LSD Ebersole Center Food Service Bid Pack 2, Addendum No. 1

Narrative of Changes

Project Name:	Ebersole Center Food Service – Equipment Replacement & Renovations SO-1853	Date:	April 3, 2026
Project Location:	3400 2 nd St Wayland, MI 49348	Architect's Project #:	26000750A
Owner/Client:	Lansing School District	Attention:	David Beckering
Issued to:	Beckering Construction	Email:	djb@beckering.com
City/State:	Grand Rapids, MI	Zip:	49548

DRAWING NUMBER:
EP101

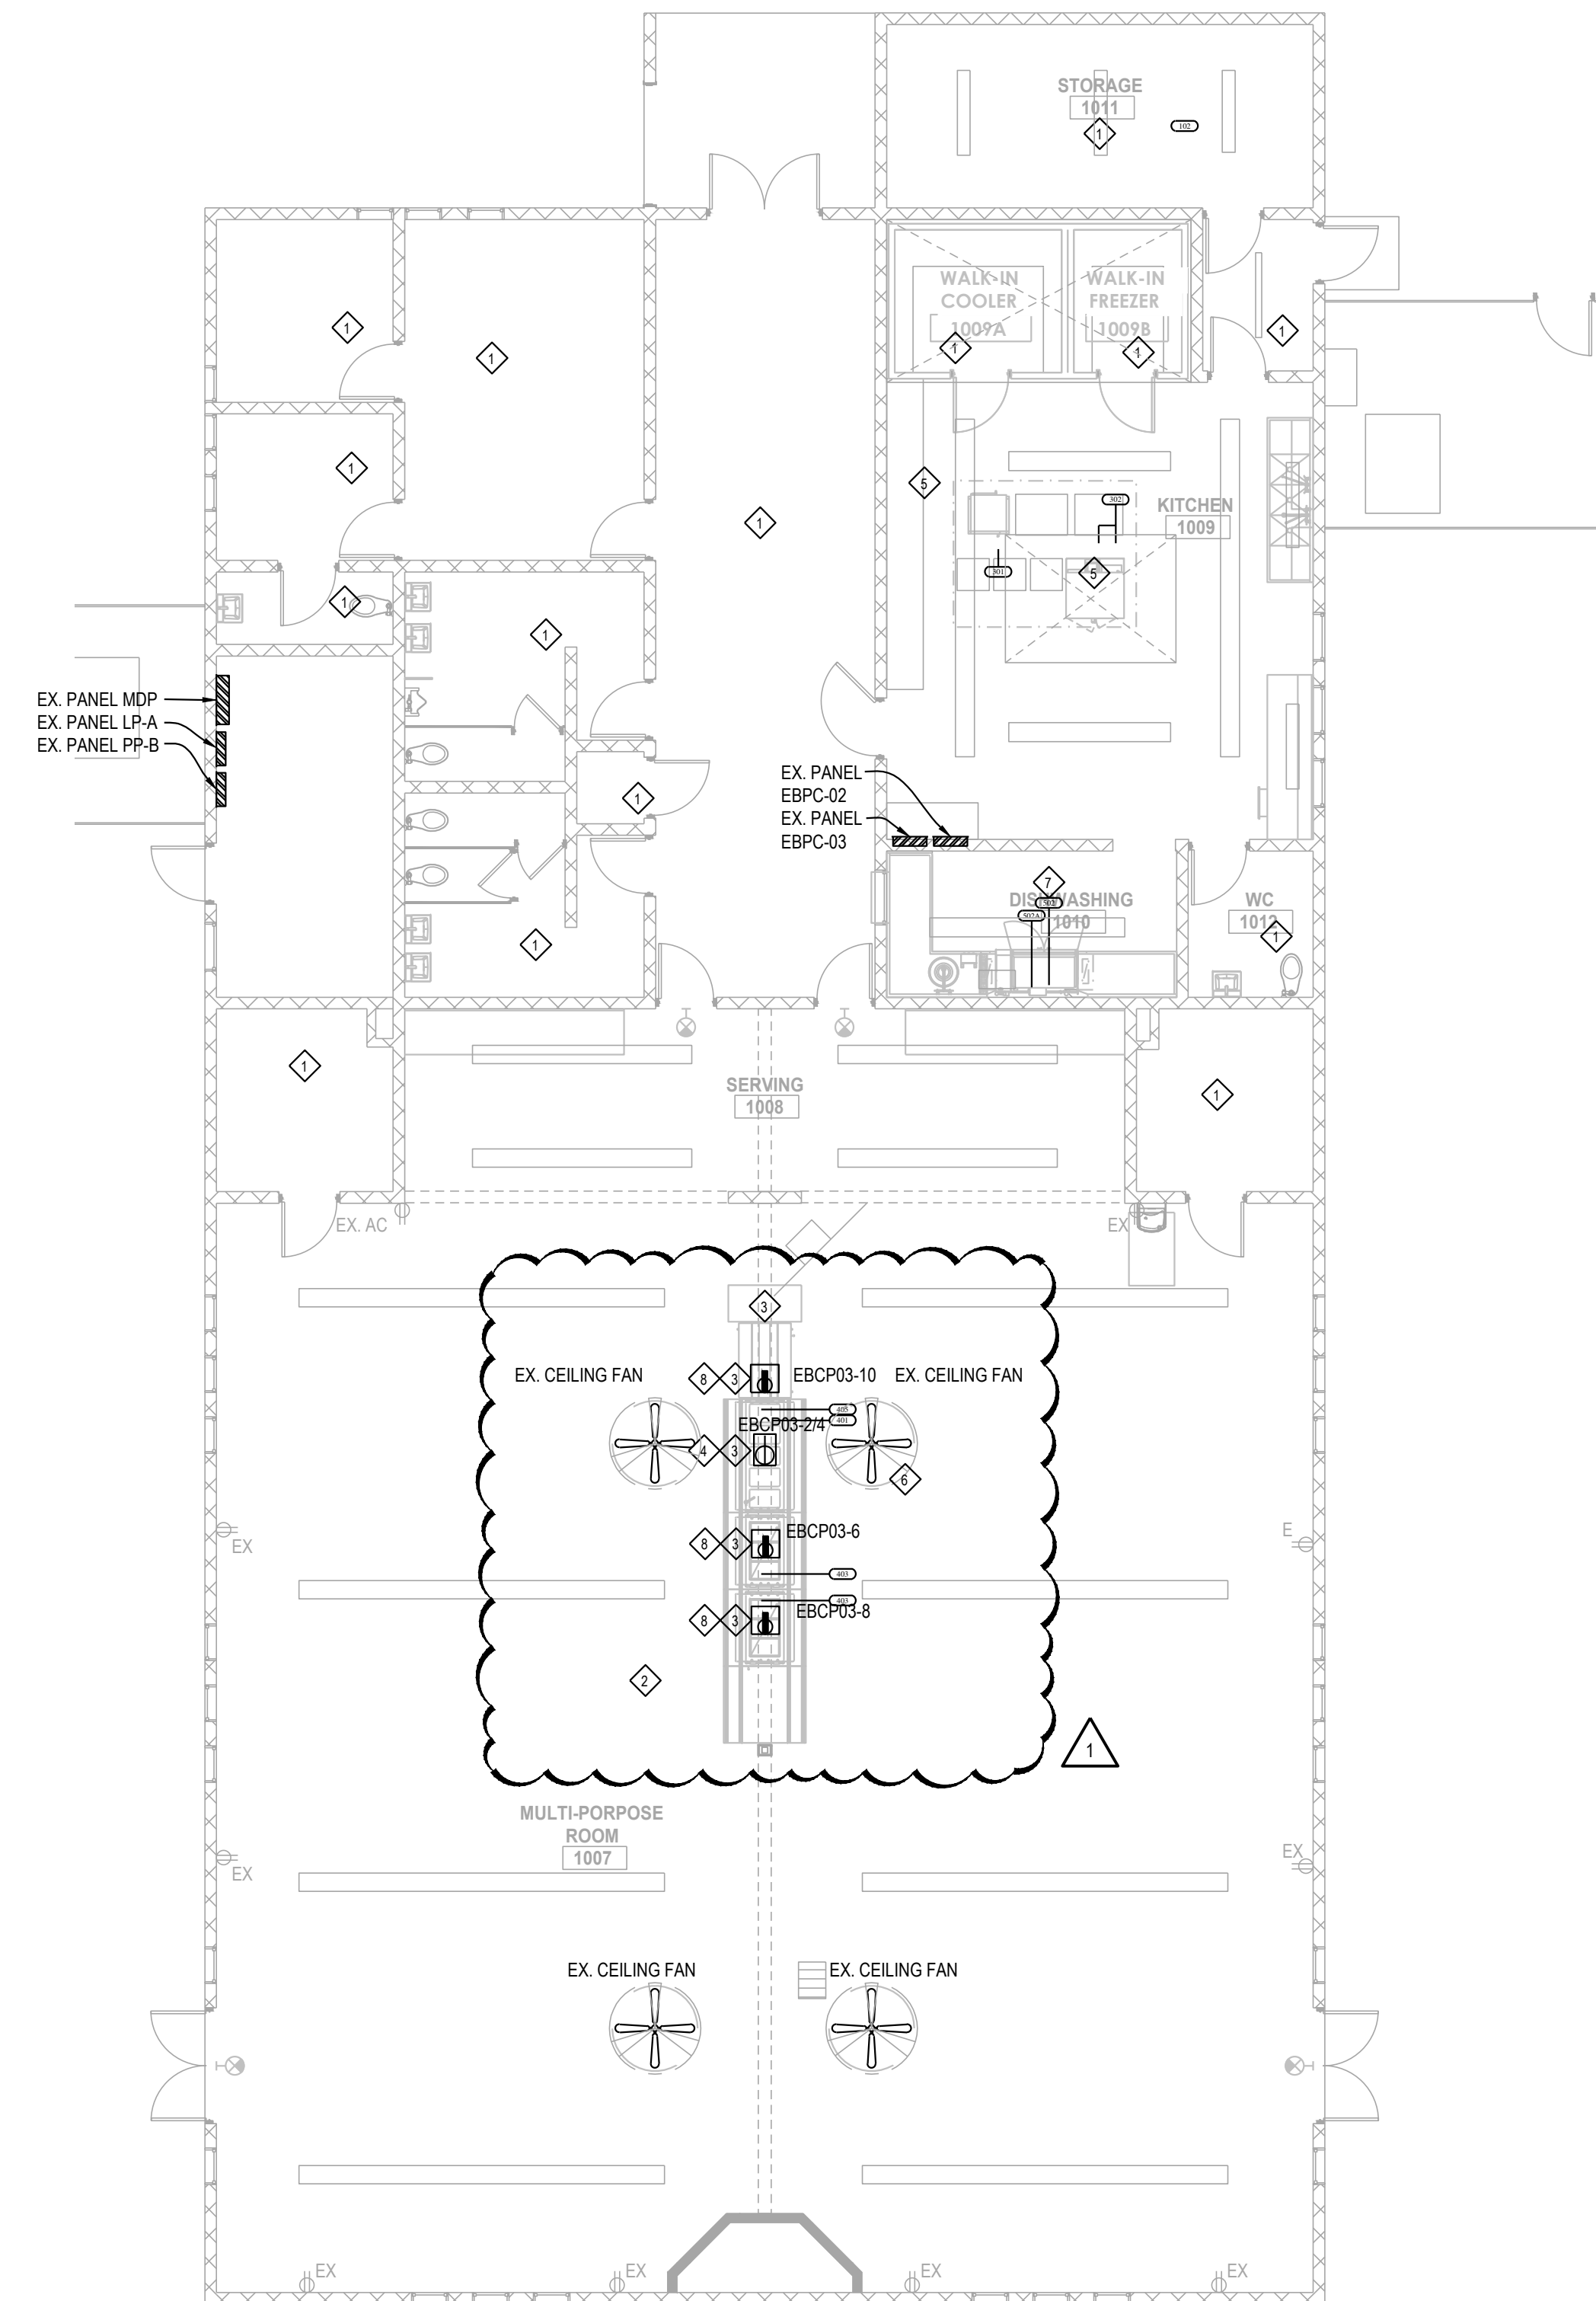
- EP101 – FIRST FLOOR PLAN – POWER (Reissued)
 - Changed keyed note 3 to utilize the column for conduit drops to serving line and provide a rubber ramp to cover surface mounted conduits along the floor.
 - Revised device layout and notations at the serving line.

- ◇ NO WORK IN THIS AREA.
- ◇ PROVIDE NEW WIRING DEVICES IN MULTI-PURPOSE ROOM WITH TAMPER RESISTANT AND STAINLESS STEEL COVER PLATES AS SHOWN ON PLAN.
- ◇ ROUTE CIRCUITS FOR SERVING LINE DOWN INSIDE THE COLUMN TO FLOOR AREA. PROVIDE SURFACE MOUNTED CONDUIT ON FLOOR TO SURFACE MOUNTED BOXES AS SHOWN ON PLAN. ELECTRICAL CONTRACTOR SHALL PROVIDE A RUBBER RAMP TO COVER THE CONDUITS EQUAL TO "RUBBER FORM" #RF-RPIF. RUN CONTINUOUS BETWEEN BOXES.
- ◇ PROVIDE 1" CONDUIT DROP WITH 3-#8 + GROUND AND FLOOR MOUNTED KEYSTONE STYLE FLOOR BOX WITH 240V/20A NEMA 14/50 RECEPTACLE. VERIFY WITH EQUIPMENT.
- ◇ REUSE EXISTING CIRCUIT, RECONNECT TO NEW EQUIPMENT, FIELD VERIFY.
- ◇ PROVIDE GFCI CIRCUIT BREAKER.
- ◇ PROVIDE NEW CIRCUIT FOR DISHWASHER AND DRAIN TEMPERING KIT.
- ◇ PROVIDE 3/4" CONDUIT DROP WITH 2-#12 + GROUND TO FLOOR MOUNTED KEYSTONE STYLE FLOOR BOX WITH 120V/20A NEMA 5-20 RECEPTACLE.
